YANKEE ATOMIC ELECTRIC COMPANY

Subject: Reactor Vessel Overpressurization

RESPONSE TO NRC QUESTIONS REGARDING
THE YANKEE ROWE SUBMITTAL ON REACTOR VESSEL OVERPRESSURIZATION

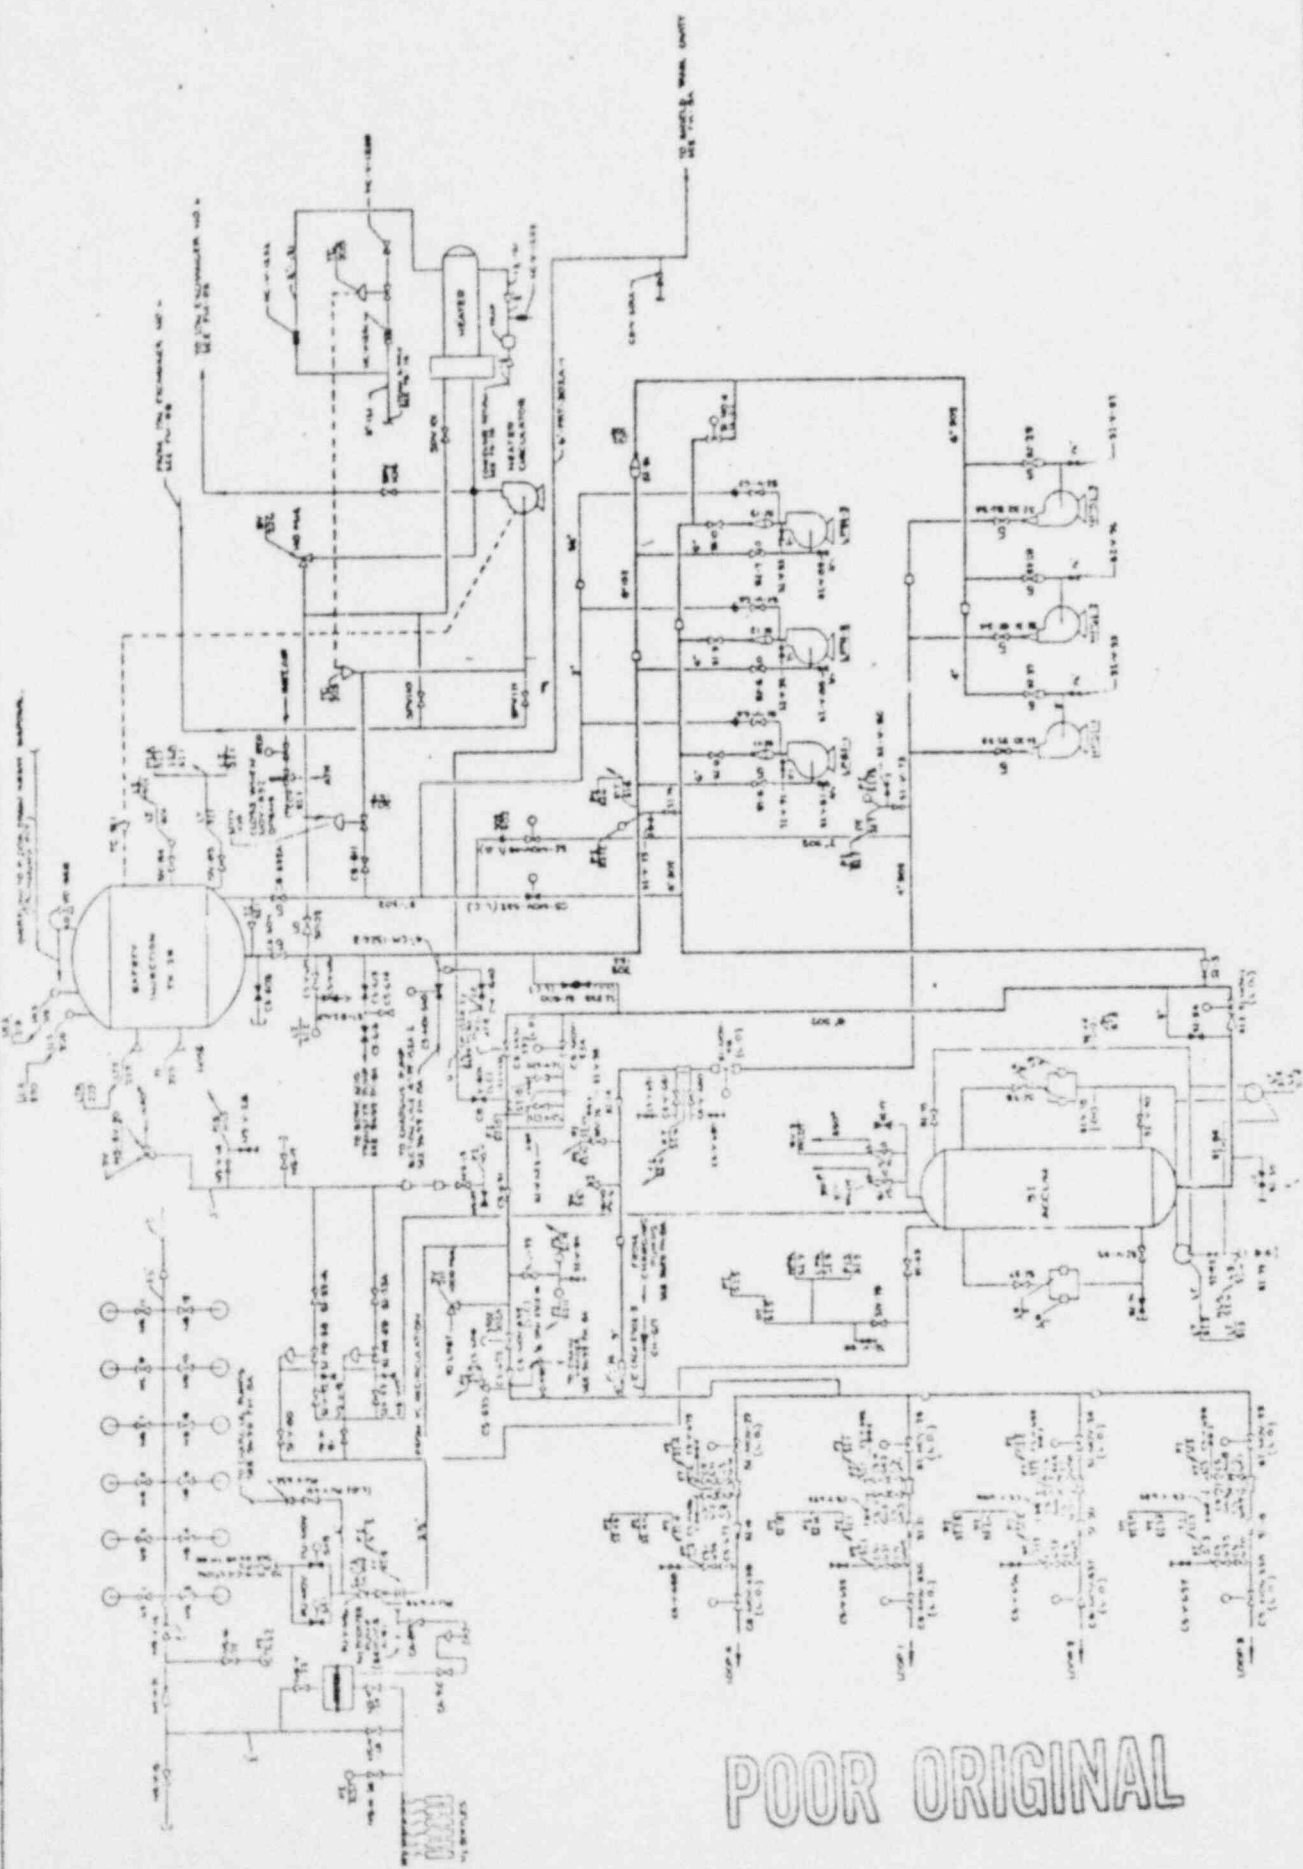
1.3.a. QUESTION: Furnish a schematic diagram of the SIS showing the components and the flow paths into the RCS. Also, provide the head flow characteristics of each of the SIS pumps.

1.3.b. QUESTION: Pages A-1 and 2 of your submittal indicate that two of the three ECCS trains are taken out of service at 1000 psig and the third at 200^oF, 300 psig. Describe how this is done, (e.g., switches or breakers repositioned). Indicate these trains on the requested schematic diagram.

1.3.c. QUESTION: You discuss the closing of selected SI header isolation valves at 1000 and 300 psig. Is the power from these valves also removed? Indicate how and from where the valves are controlled. Identify them on the requested schematic diagram.

I.3.d. QUESTION: Indicate on the schematic diagram any other pumps that are disabled and valves which are in an off-normal position during a cold, and shutdown condition.

ANSWER: Attachment A is a schematic diagram of the SIS. Attachment B and C are pump characteristic curves for the low pressure and high pressure pumps respectively.

ANSWER: A safety injection pump is removed from service by racking out, locking and tagging its ACB. A train consists of one high pressure and one low pressure pump. As indicated on Attachment A a train would be HPSI-1 and LPSI-1.

ANSWER: Below 1000 psig the following valves are closed but electrically operable: SI-MOV-22, SI-MOV-23, SI-MOV-24 and SI-MOV-25. At less than 300 psig the following valves are closed but electrically operable: SI-MOV-46, CS-MOV-533, CS-MOV-534, CS-MOV-535, CS-MOV-536, CS-MOV-537, CS-MOV-538 and CS-MOV-539. These valves

ANSWER: At less than 1000 psig the safety injection accumulator is removed from service by locking closed, tagging and making electrically inoperable, SI-MOV-1. In addition nitrogen regulator isolation valves SI-V-52A and SI-V-53A are tagged and locked closed and NS-V-19 is opened to vent the accumulator.

SKETCH #1

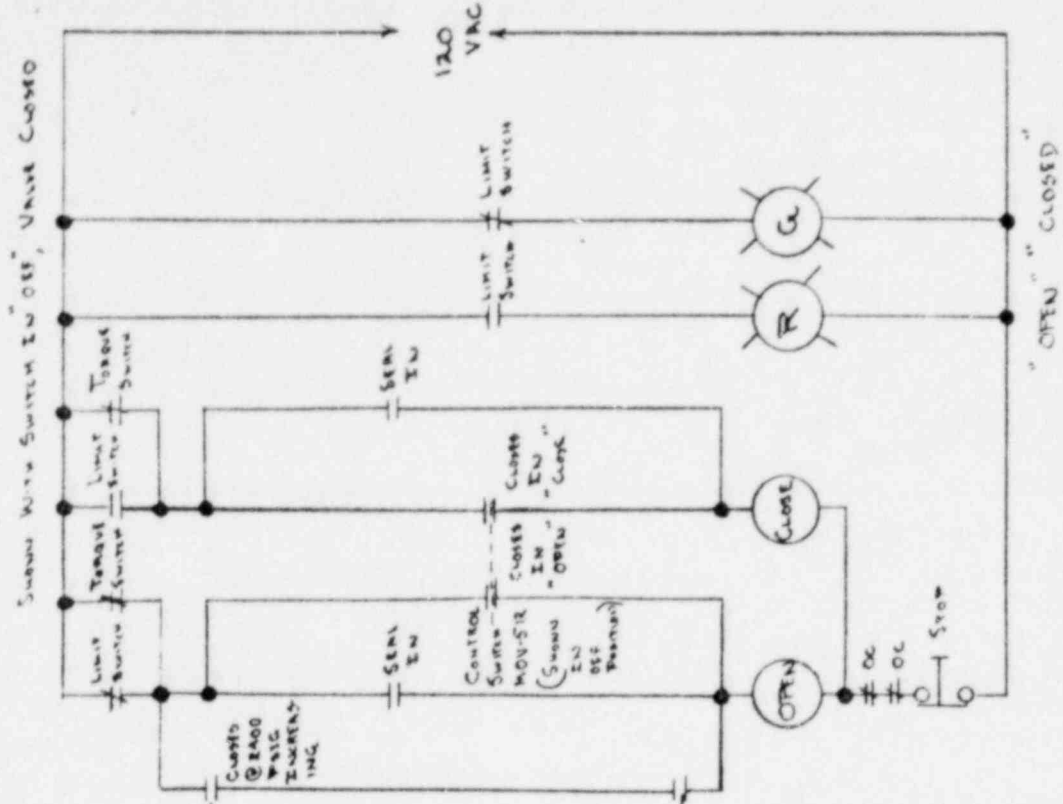
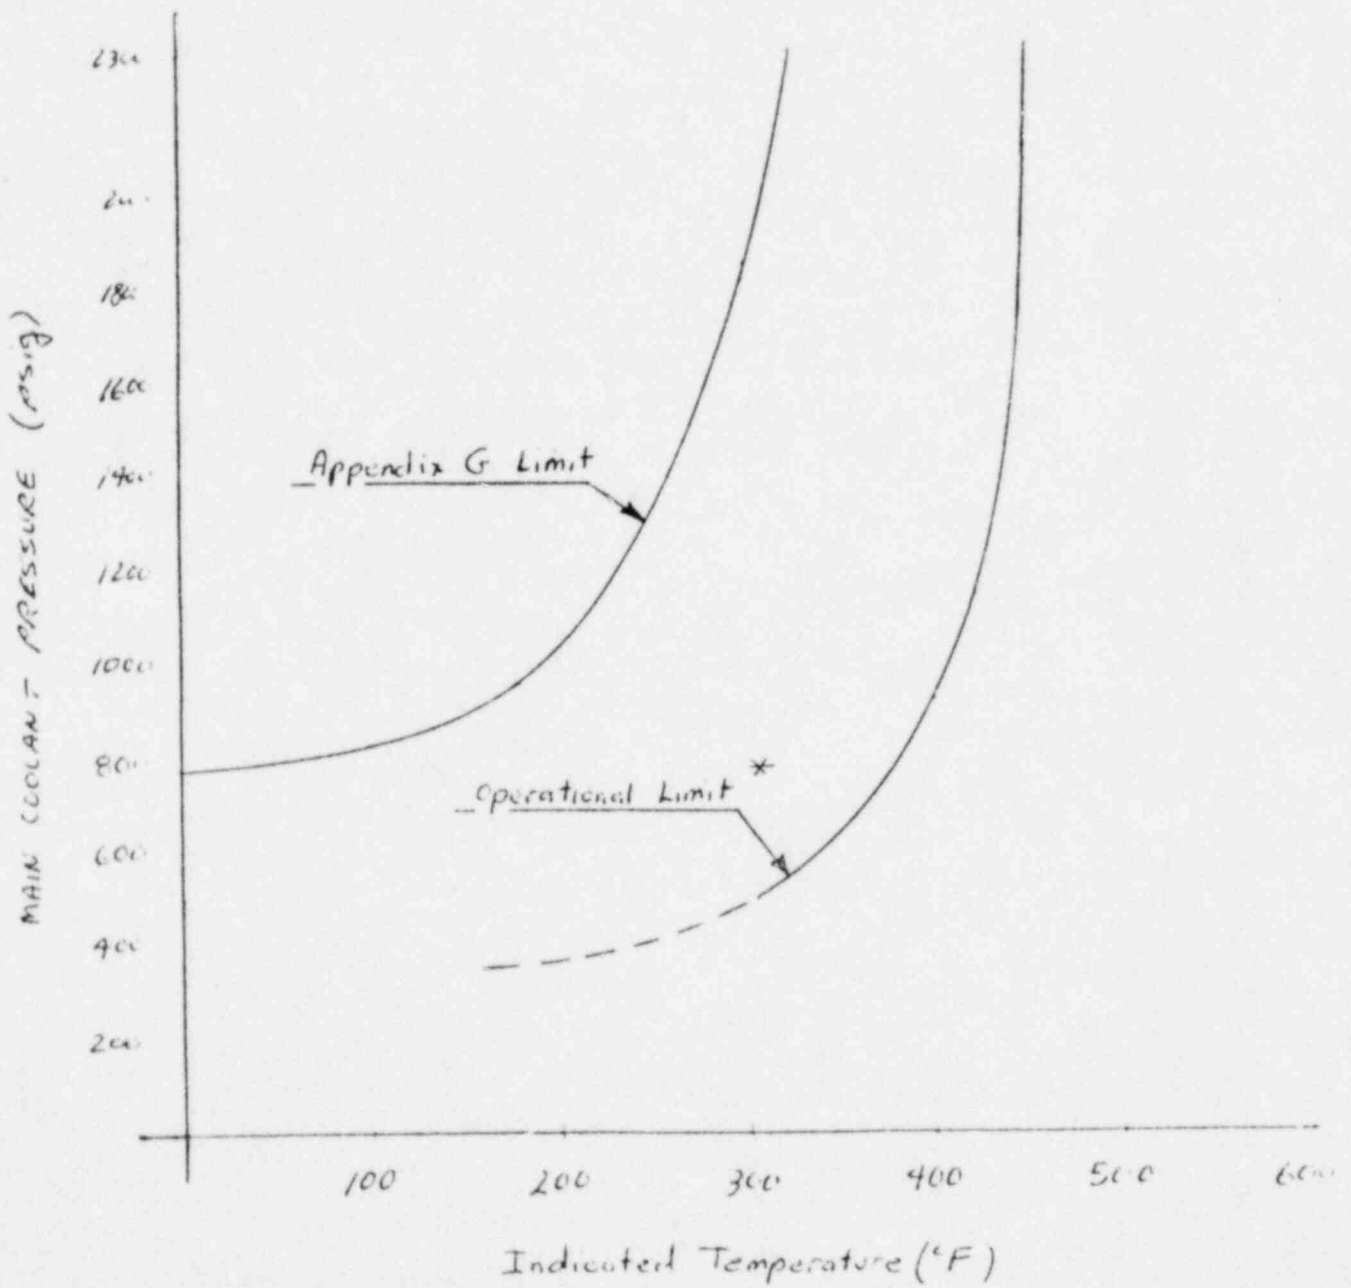
11.3. QUESTION: Provide prints of the existing and proposed circuitry used to operate the solenoid on the pressurizer relief valve. These diagrams should enable us to trace signals from the detector to the solenoid.

ANSWER: The following attached sketches describe the existing and proposed circuitry.

FIGURE III. 3

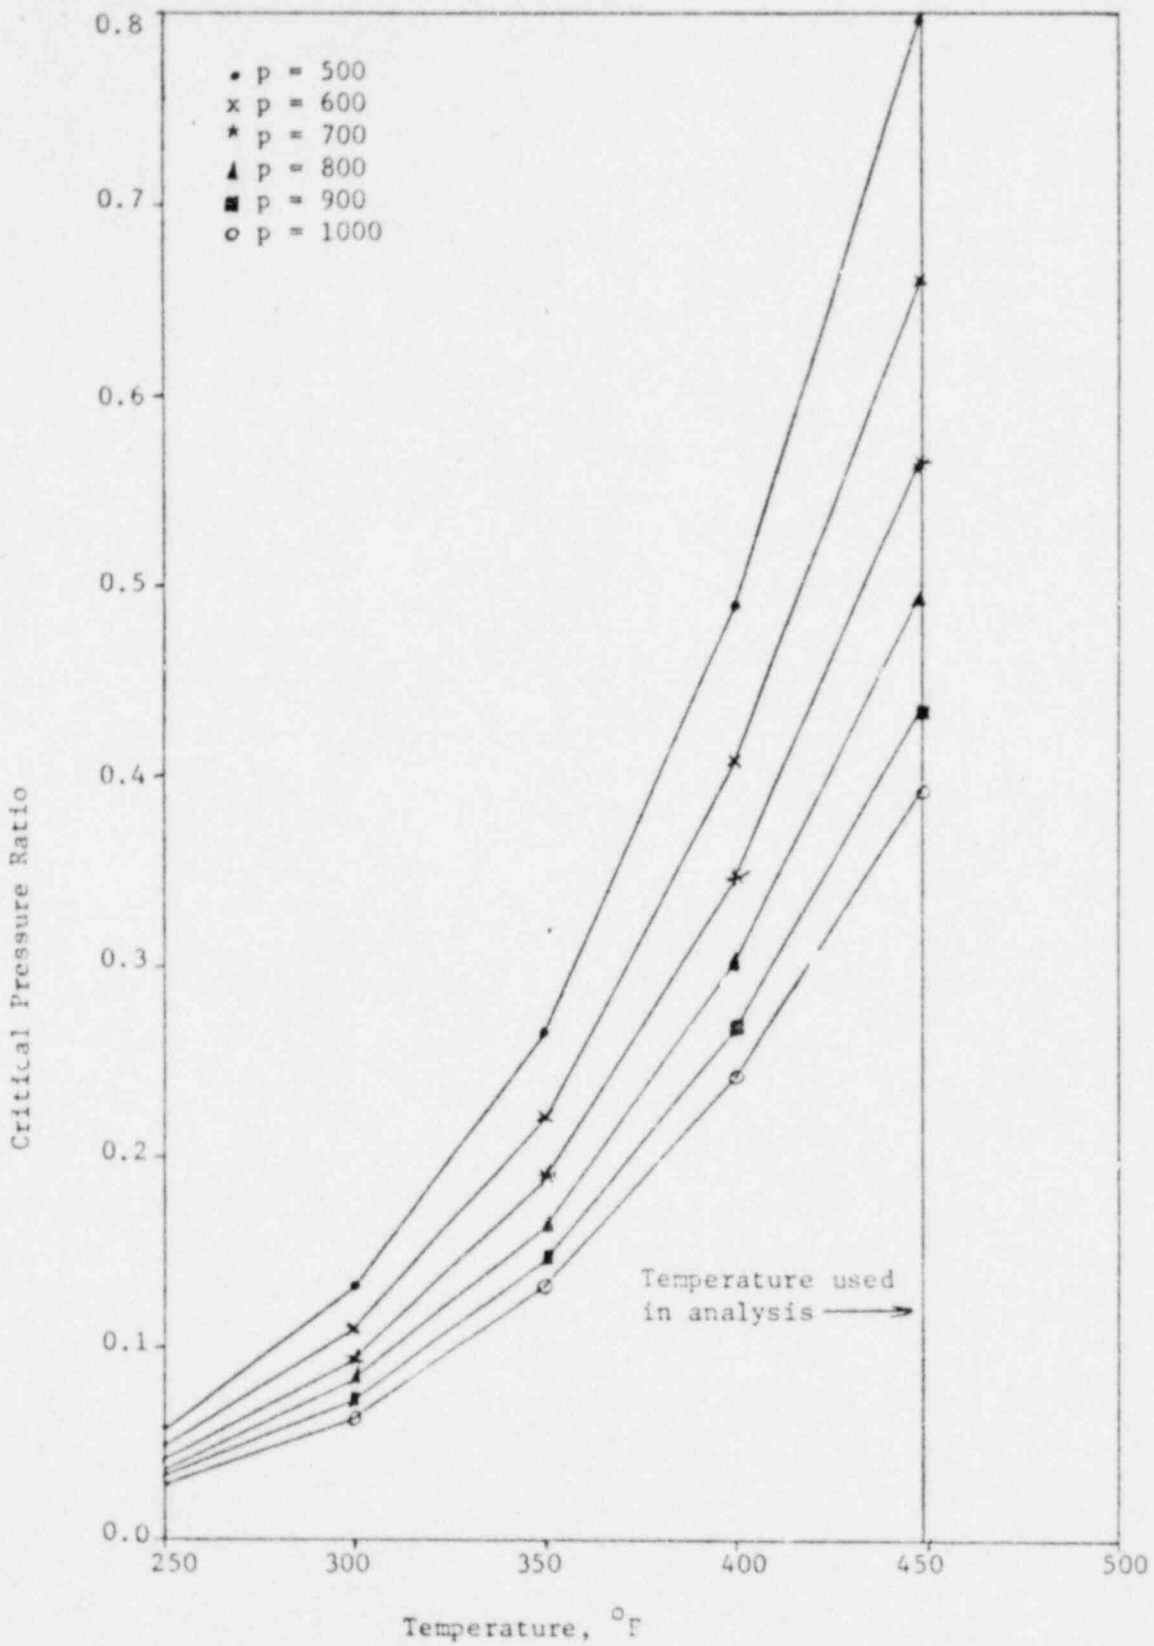
- a. Perform a RCS transient pressure analysis assuming a non water-solid pressurizer and an inadvertent injection from a single ECCS train. State your initial conditions.
- b. Since the RCS is made water solid at around 180 °F on a system cooldown (Appendix A), and the third ECCS train is tagged out when the RCS temperature is < 200°F, perform the same analysis as above assuming a water-solid system. (Assume a RCS temperature of about 180°F).
- c. How sensitive is the predicted RCS pressure response in the above analyses to the initial RCS temperature and pressure (assuming accumulation effects on relief valve performance)?

Figure III.3 is a simplified flow diagram of a single ECCS train. This drawing illustrates the series-parallel flow paths provided for the LPSI and HPSI pumps. This arrangement provides series flow (through the LPSI then HPSI pump) when main coolant pressure is high; and parallel flow which effectively bypasses the HPSI pump when system pressure is low. This inherent characteristic of each ECCS pump train comes into play in the postulated event under consideration.
